PROJECT NAME: RUTLAND CITY	PLOT DATE: 11/5/2013
PROJECT NUMBER: STP 019-3(57)	DRAWN BY: PZA
FILE NAME: ...rvt.lgt.det.dgn	CHECKED BY: GAE
PROJECT LEADER: GAE	SHEET 36 A OF 392
DESIGNED BY: TFD	
LIGHTING DETAIL LGD-01

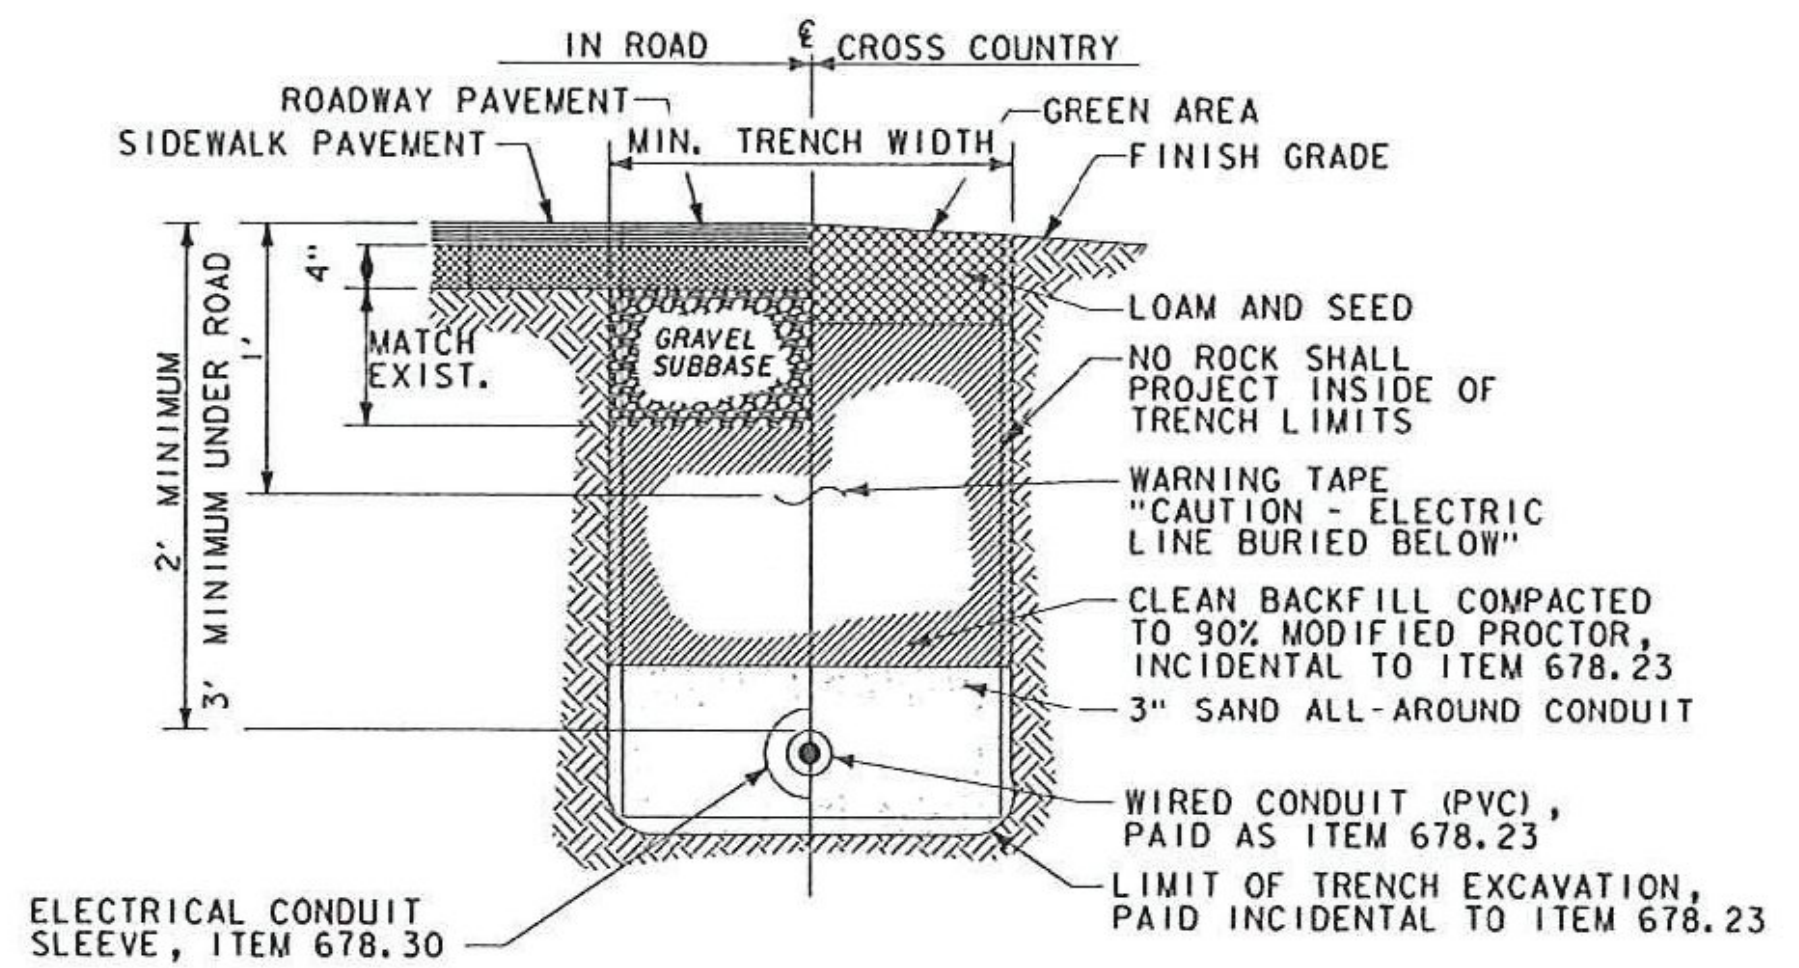
REVISION	BY	DATE
△ CONDUIT AND LIGHTING REMOVED FROM CONTRACT	TFD	11/05/13
